True Street Subdivision

41-41 True St, Portland, Maine

PLANNING BOARD REPORT PORTLAND, MAINE

True Street Subdivision
True Street
Amendment to Subdivision Plan
Project ID 2011-382
Todd and Kelly Sniper, Applicant

Discussion at 3.8.06 Dev Rev.

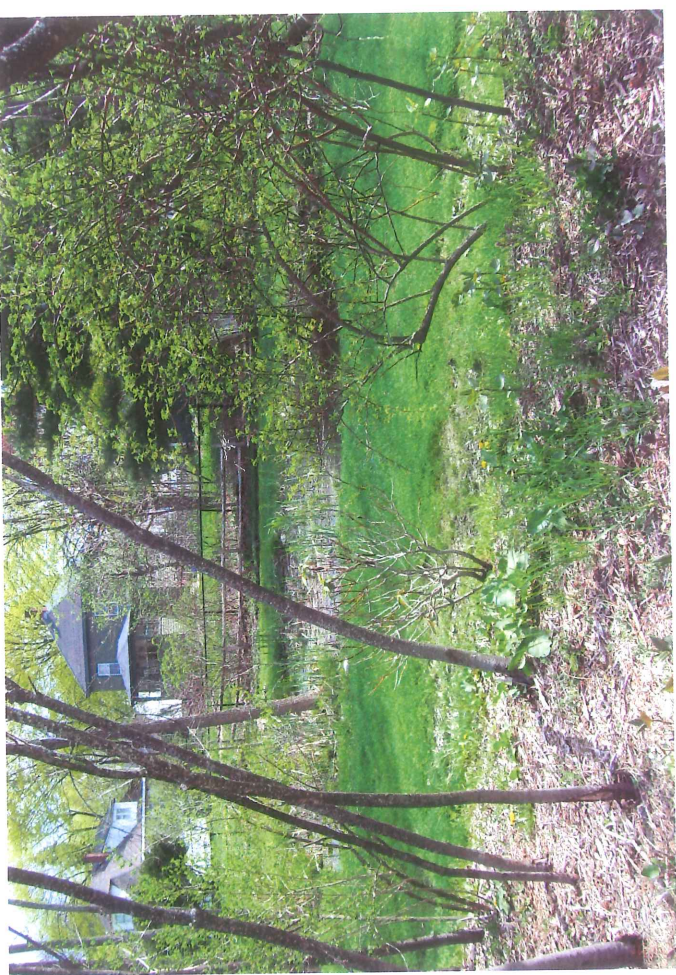
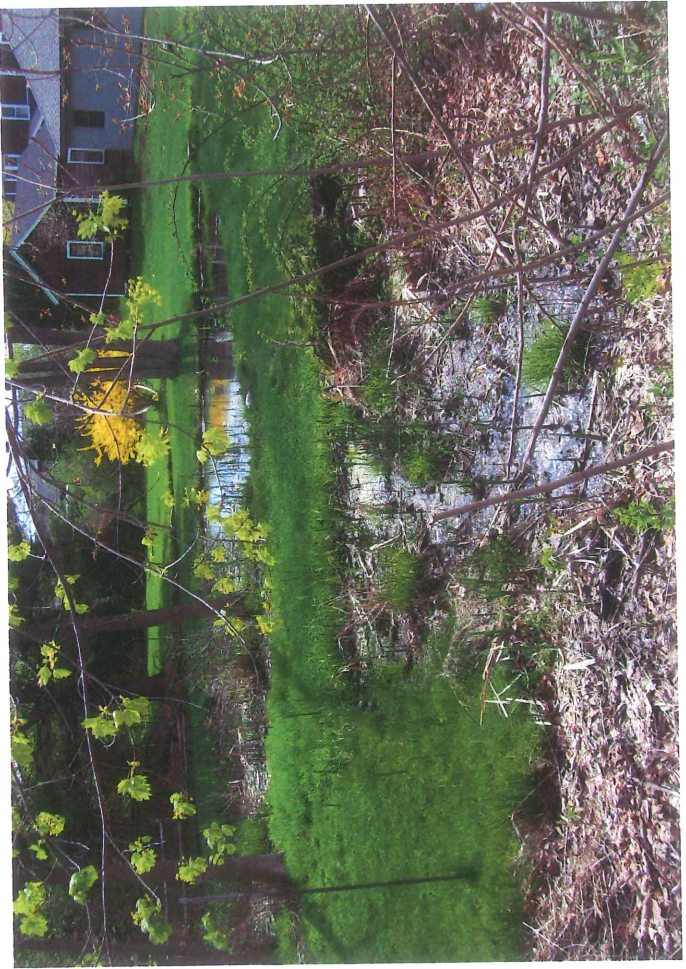
- 1) width of Tru, hammerhead + width of should drive are main concern - ? cul-de-sac
- 2) Emergency access + City obligations are main - not just bureaucratic
- 3) Zoning + some of Shermans need amendment but not fundamental
- 4) Other details needed but 1) needs to be decided asap w/ workshop 3.28.06
- 5) If do letter as DB has been for drive w/ applicant

FIGURE I-6
TYPICAL TURNAROUND DETAIL

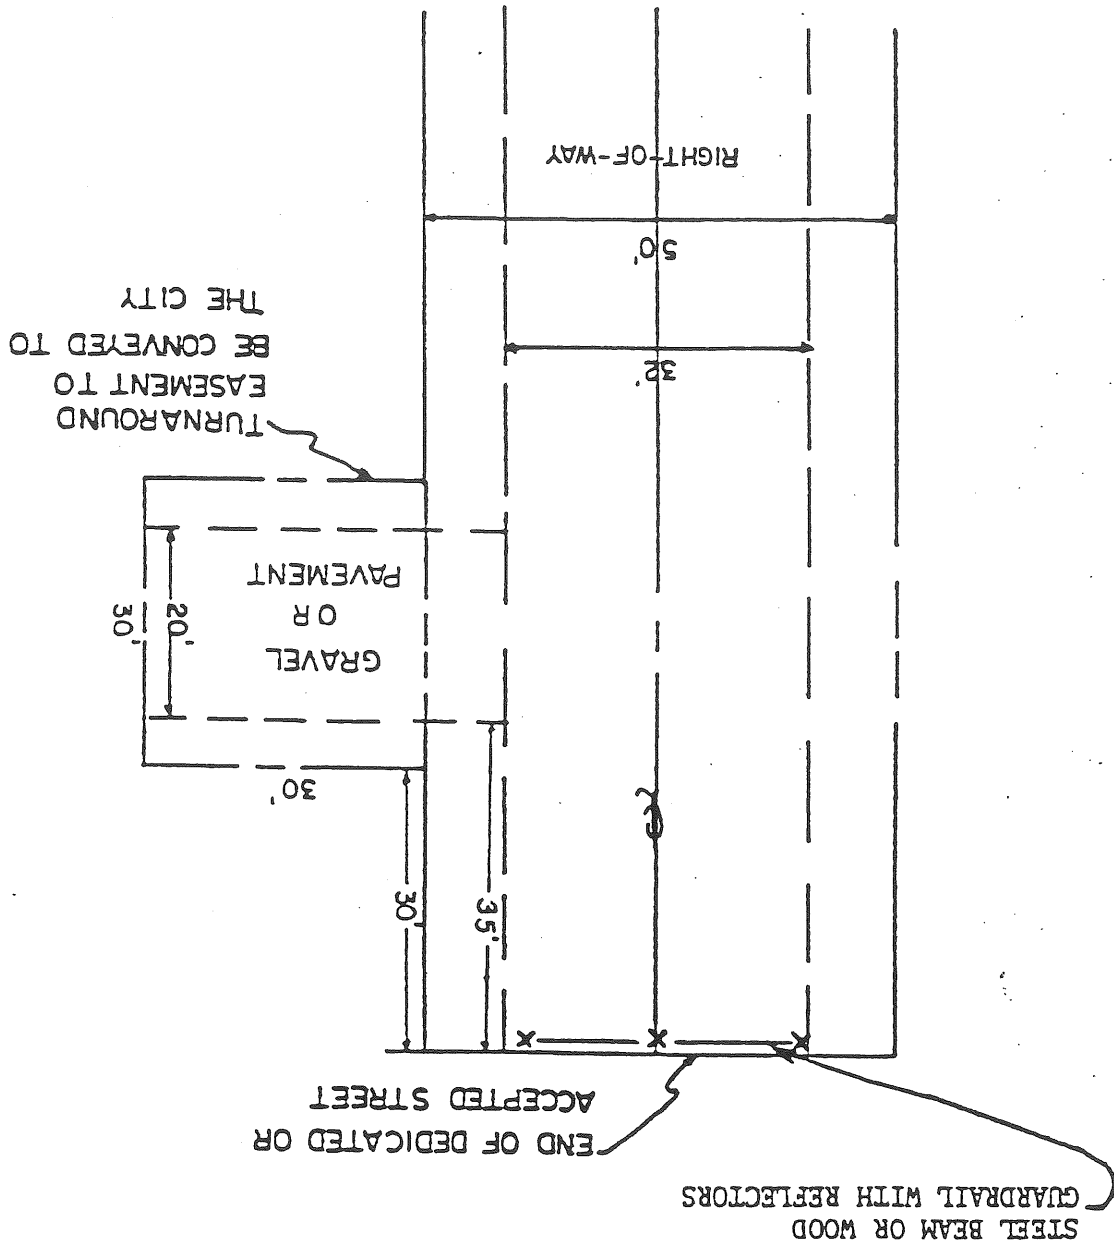
The Department of Public Services would like to see the turnaround located closer to the end of the street. For reference, I have attached a copy of the City's design standard for a typical turnaround. This detail shows the preferred location of a turnaround with respect to the end of a street.

The DPS has no objection to the proposal to provide 12 feet at the end of True Street for snow storage, even though this aspect of the proposed design does not match the City's design standard.
